# Access Compliance Report

### (Curb Ramps)

Intersection ID: 11981	Main Street: W_6TH_ST	Cross Street: N_CHURCH_ST	Location: S
ADA ID: 2876B78A4207	Ramp Type: PerpDiag	Initial Pass/Fail: Fail	Overall Compliance: No
Codes/Mitigation Info/Possible Solution		Field Measurements/Component Compliance

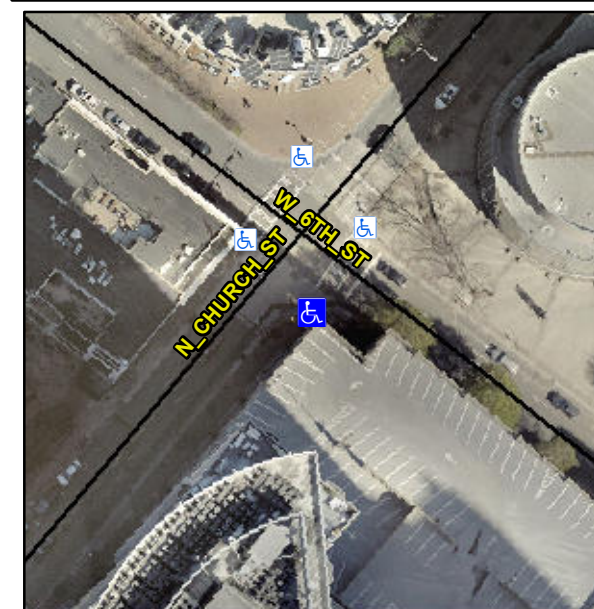
**Not Found, R304.2.2, R304.5.3**

Compliance	Description	Data	Compliance	Description	Data
N/A	Ramp Length (in)	78.0	No	Ramp Slope (%)	11.4
Yes	Ramp Width (in)	115.0	No	Ramp XSlope (%)	2.9
N/A	Flare Type LT	N/A	N/A	Flare Type RT	N/A
N/A	Flare Slope LT (%)	N/A	N/A	Flare Slope RT (%)	N/A
N/A	Flare Traversable LT?	N/A	N/A	Flare Traversable RT?	N/A
N/A	Landing Length (in)	N/A	N/A	DWS Provided?	N/A
N/A	Landing Width (in)	N/A	N/A	DWS Contrast?	N/A
N/A	Landing Slope (%)	N/A	N/A	DWS Length (in)	N/A
N/A	Landing X Slope (%)	N/A	N/A	DWS Full Width?	N/A
N/A	Landing Curb? (Y/N)	N/A	N/A	DWS Offset (in)	N/A
N/A	Shared Landing?	N/A			
N/A	Gutter Ponding?	N/A	N/A	Gutter Slope (%)	N/A
N/A	Gutter Lip Ht (in)	N/A	N/A	Gutter X Slope (%)	N/A
N/A	Painted X Walk1?	Yes	N/A	Painted X Walk2?	No
	X Walk 1 Direction	To NE		X Walk 2 Direction	To NW
N/A	X Walk 1 Width (in)	105.0	N/A	X Walk 2 Width (in)	N/A
	X Walk 1 Slope (%)	3.8		X Walk 2 Slope (%)	1.1
	X Walk 1 X Slope (%)	4.0		X Walk 2 X Slope (%)	2.0

**Remove & Replace Curb Ramp With Two New Directional Ramps or Equivalent.**
